1980-1985 RX-7 & 1981-1985 GLC

SUBJECT Whistle Noise from Check & Cut Valve.

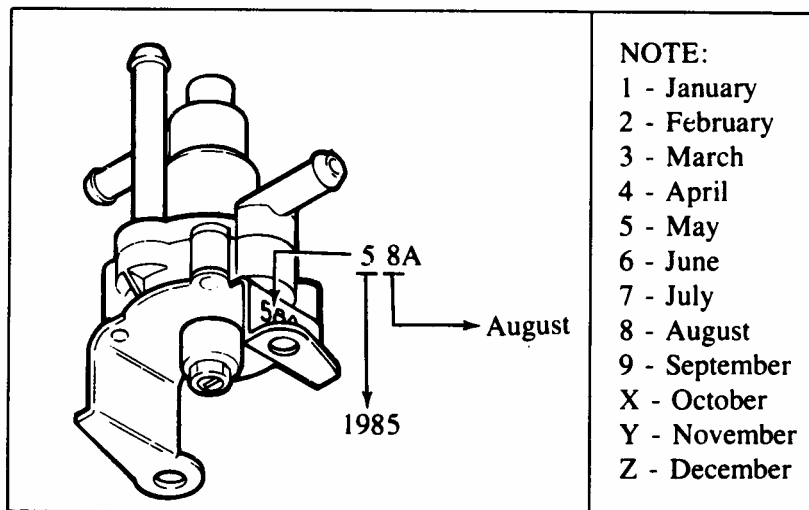
The part numbers of 8341-42-910 for RX-7/GLC and BA01-42-910 for GLC have not been changed, however, a modified check & cut valve can be distinguished from an unmodified one by the production date stamped on the bracket as shown.

The check & cut valves produced on and after the following date are the modified ones.

RX-7 August 10, 1985 (58A)
GLC September 1, 1984 (49A)

If a customer complains about the whistle noise, replace the check & cut valve with the modified one.
